**PLANNED UNIT DEVELOPMENT
STAFF REPORT****Date: November 15, 2007****DEVELOPMENT NAME**

Chartersouth, Inc.

Planned Unit Development Approval to allow shared access between two building sites.

SITE PLAN

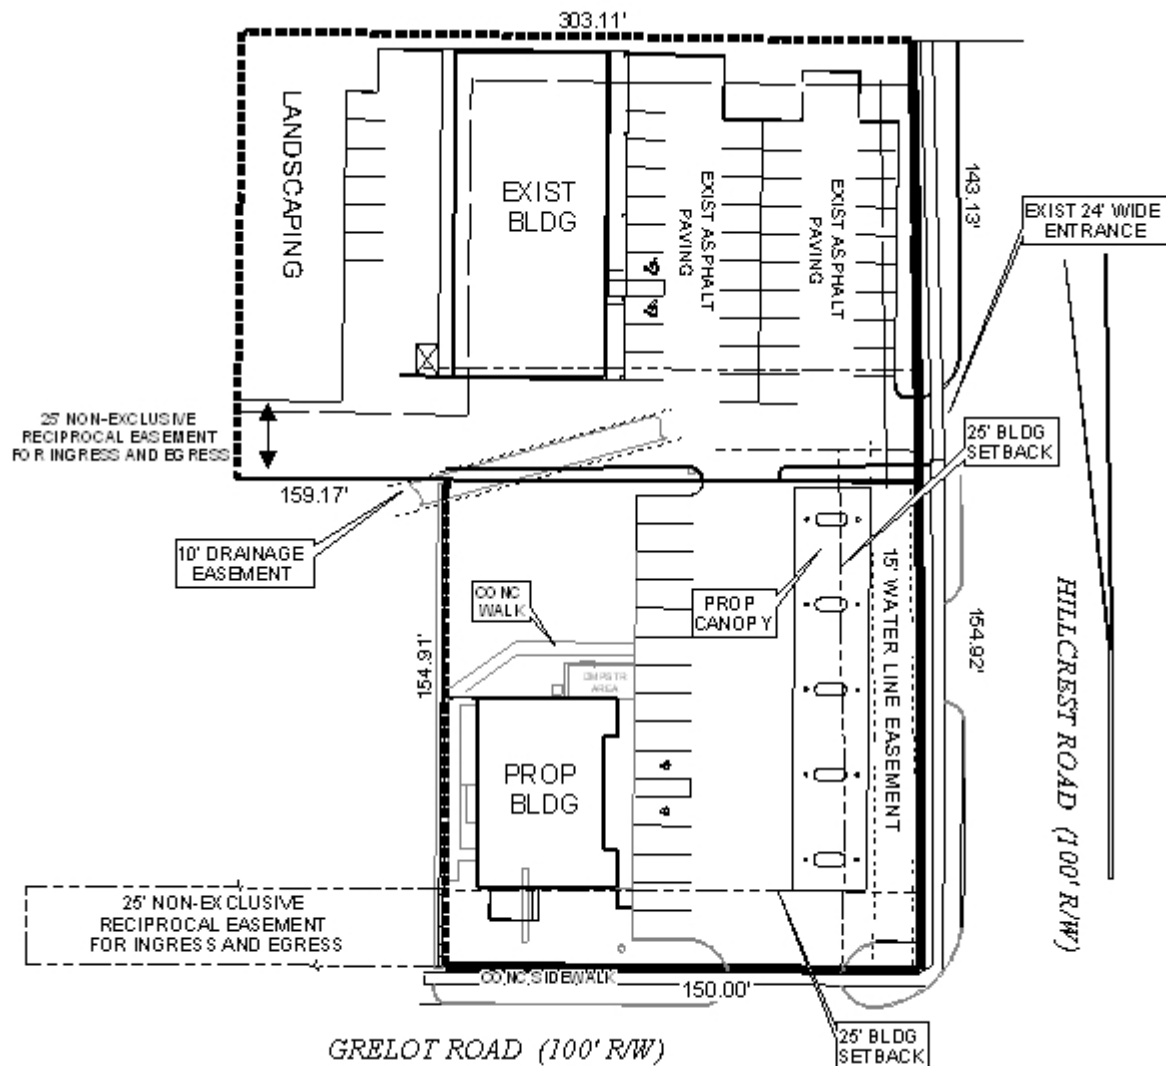
Driveway number, sizes, location and design to be approved by Traffic Engineering and conform to AASHTO standards. The thirty foot and thirty-five foot driveways to not meet current city standards and changes should be made to accommodate these standards.

The site fronts onto Hillcrest Road and Grelot Road, both major streets, with adequate right-of-way, and access management should not be a concern due to the location of two existing curb cuts, one along each major street. However, the curb cuts should be improved as recommended by Traffic Engineering with the size, design and location to be approved by Traffic Engineering, (The thirty foot and thirty-five foot driveways to not meet current city standards and changes should be made to accommodate these standards) and conform to AASHTO standards.

- 1) the submission of the revised PUD plan, prior to permitting, illustrating the changes as required by Traffic Engineering;
- 2) compliance with the lighting requirements of Sections 64-4.A.2. and 64-6.A.3.c. of the Zoning Ordinance; and
- 3) full compliance with all other municipal codes and ordinances.
